**LAKE GERALDINE DAM
DAM SAFETY INSPECTION 2022 #1
IQUALUIT, NUNAVUT**

PRODUCED FOR: THE CITY OF IQUALUIT
C/O COLLIERS PROJECT LEADERS

PRODUCED BY: CONCENTRIC ASSOCIATES INTERNATIONAL INCORPORATED

DATE: JUNE 30, 2022

Photograph 7 –Sink hole within the south access road, approximately 40' south of the access gate.

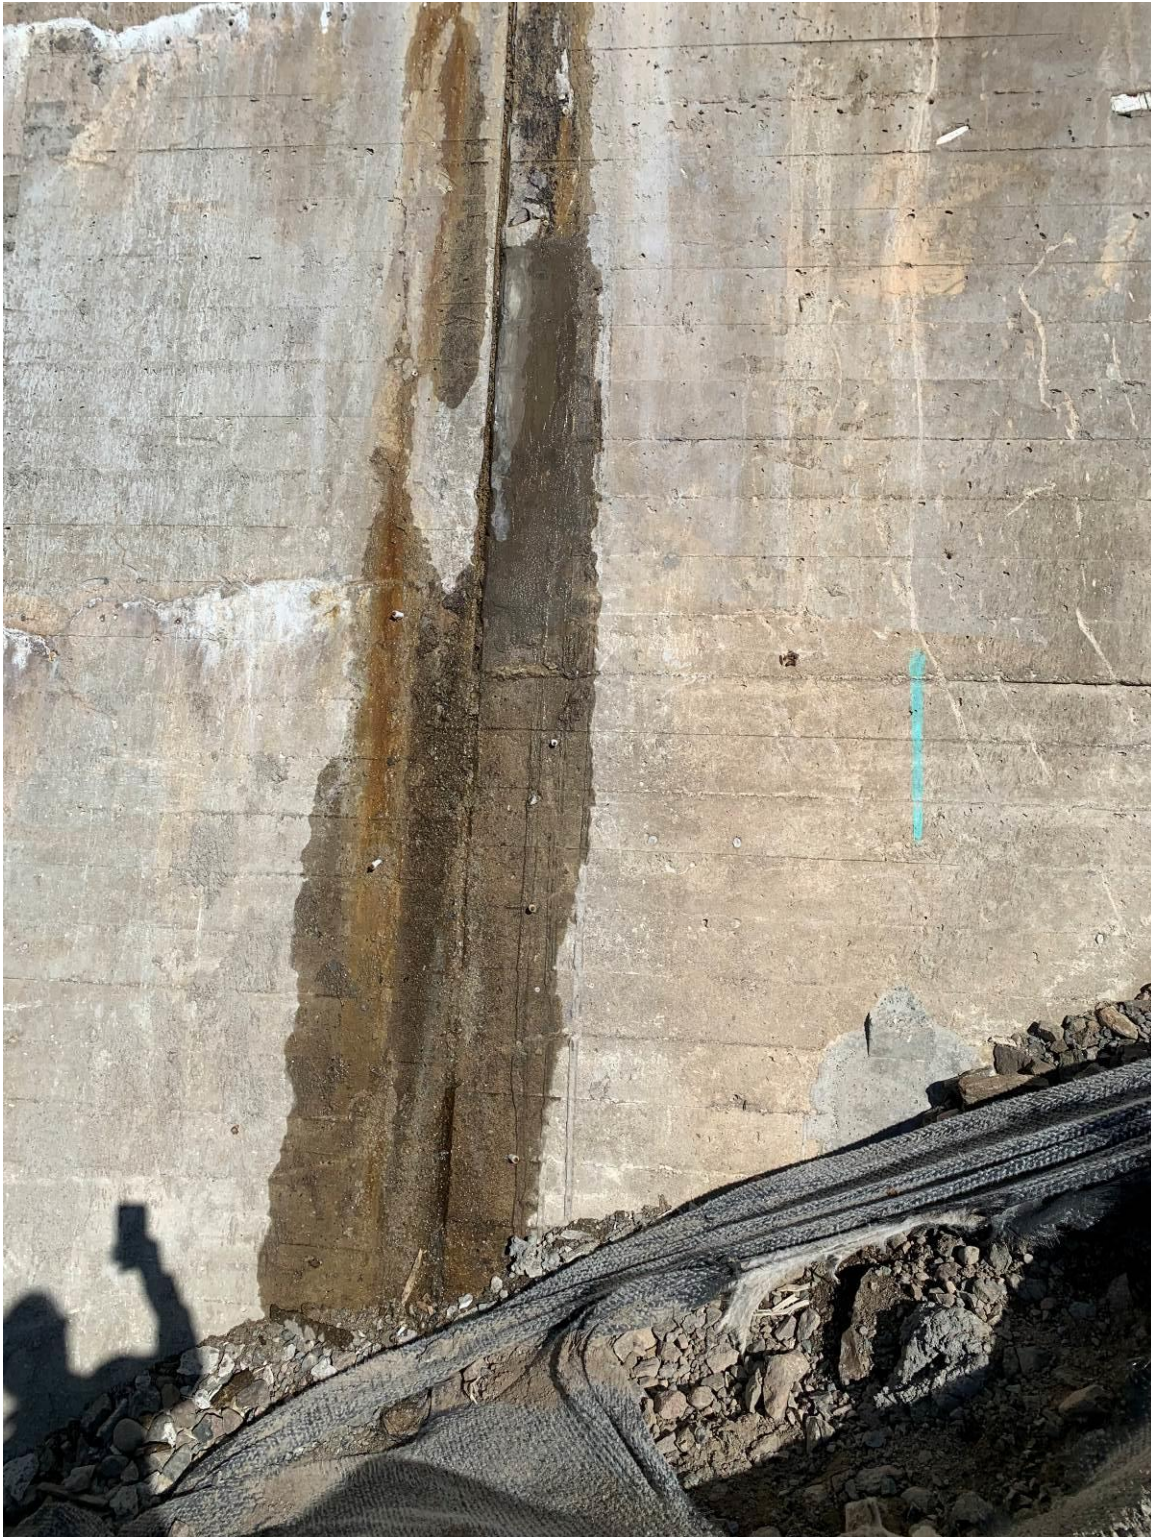
Photograph 6 –Sink hole within the south access road, approximately 40' south of the access gate.

Site Plan – Concrete Dam, Center and North Berms

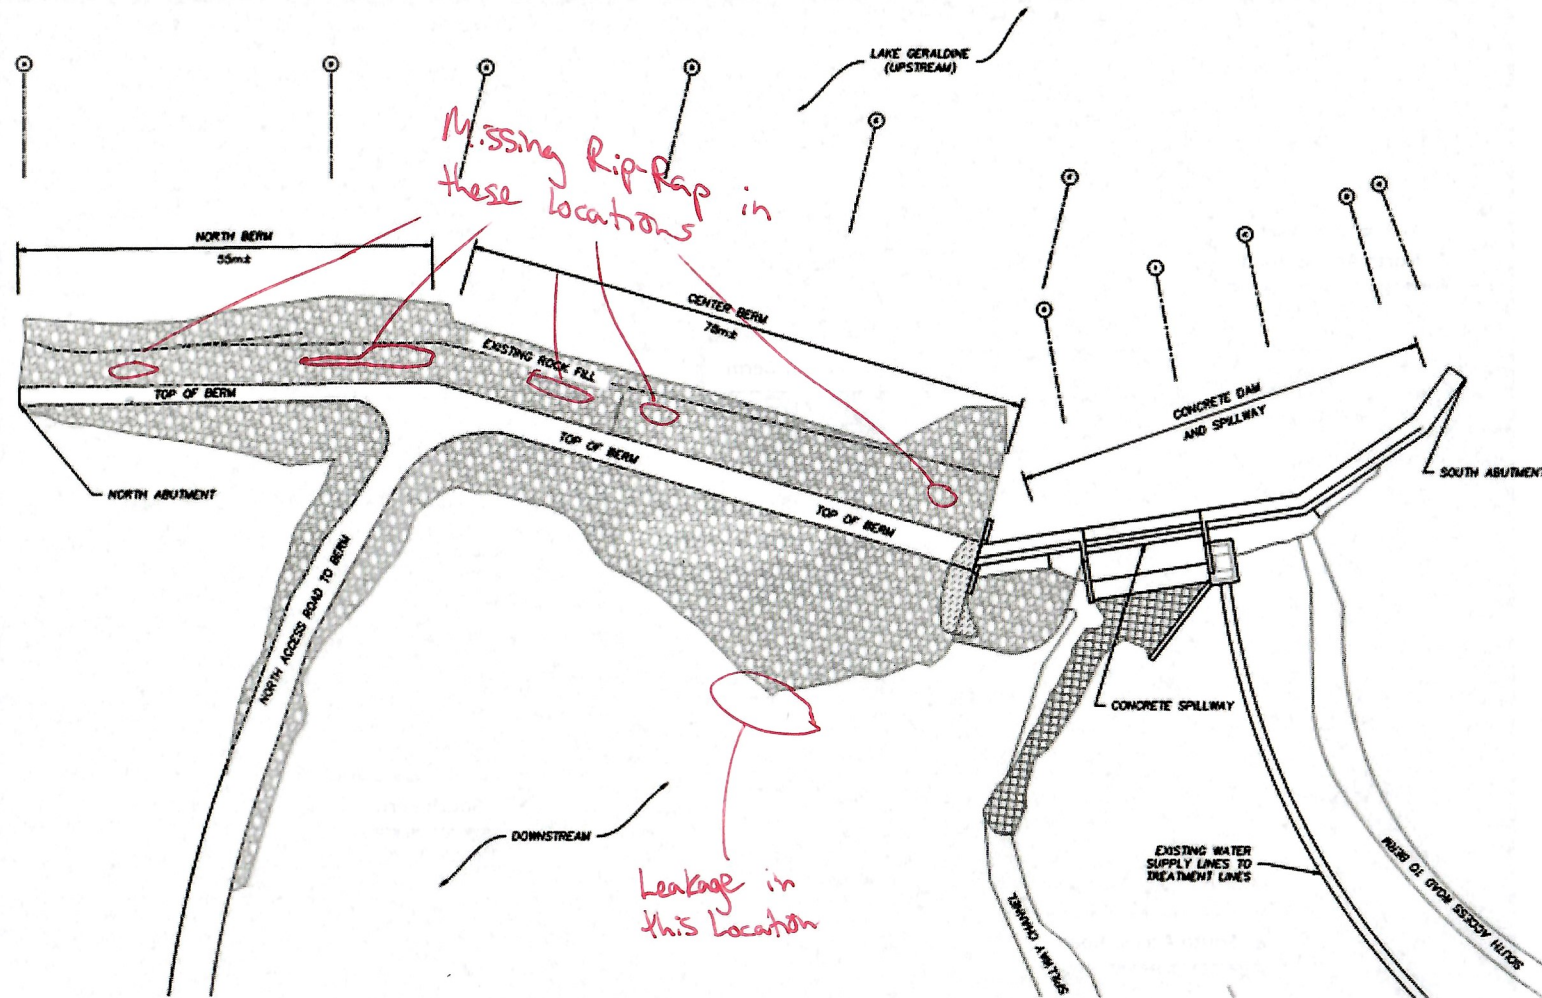
Description	Yes	No	Observations	Action Required
Displaced rip-rap /armor stone on the upstream face of berm	X		Same locations as previously identified, see markups on site layout plan	
Displaced rip-rap /armor stone on the downstream face of berm		X		
Transverse / longitudinal cracking, within the Top / crest of the berm (Indicate if new, existing, expanded, length, width)		X		
Transverse / longitudinal cracking, within the Upstream face of the berm (Indicate if new, existing, expanded, length, width)		X		
Transverse / longitudinal cracking, within the Downstream face of the berm (Indicate if new, existing, expanded, length, width)		X		
Wet area or active leakage / seepage within the downstream side face of berm Is there silt / sand within the leaking water		X		
Ponding water at base of the berm (downstream), is there sand or silt suspended within the water		X		
Additional Comments, Sketches or Observations

Elevation – Downstream Face, Concrete Dam and Spillway

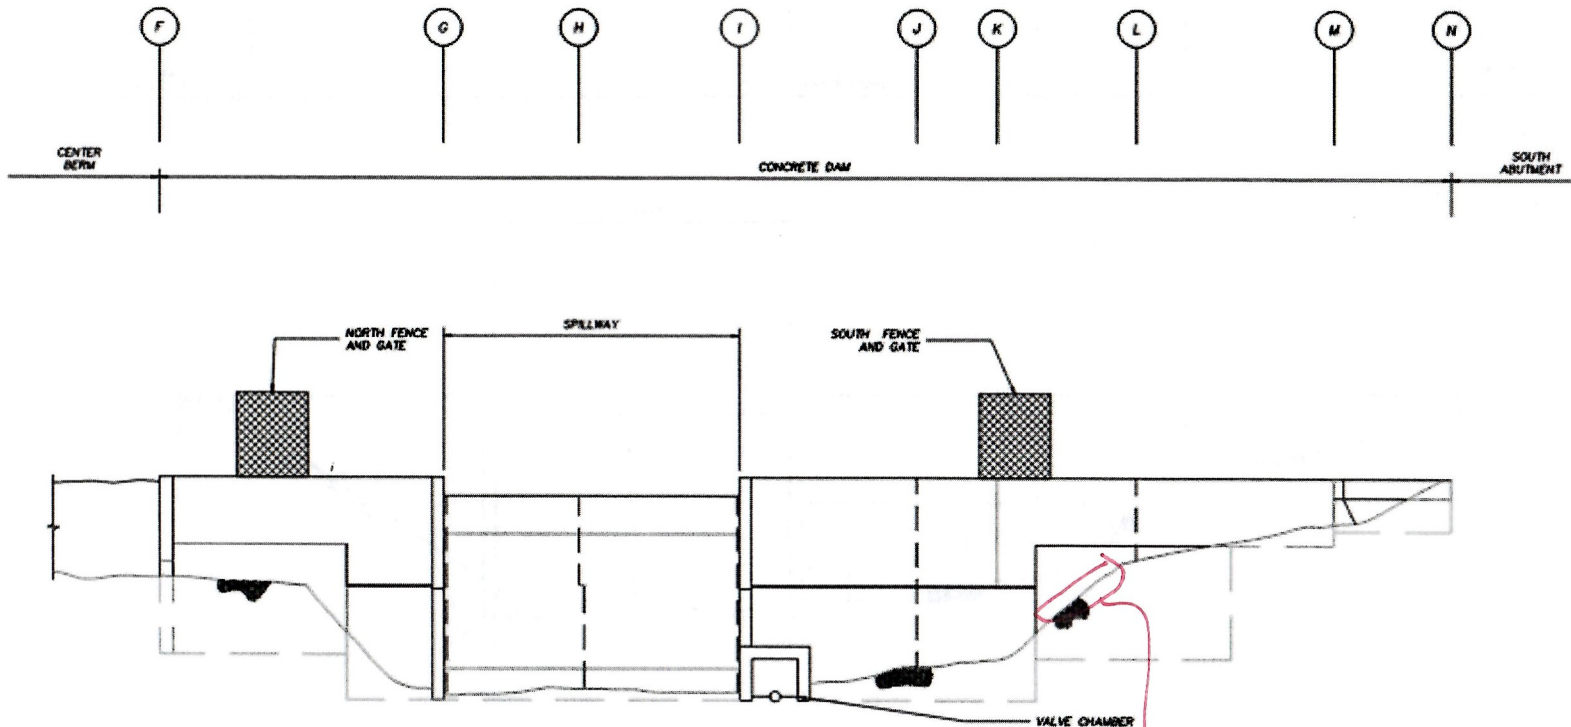
- No change in condition to the small rut identified in the previous report at the north end of the south berm (presumably from a vehicle).
- Leakage was observed at the base of the interface between the bedrock and the concrete dam. Leakage of water has been observed at this location during previous inspections. This leakage is steady and constant.

Leakage in
this location
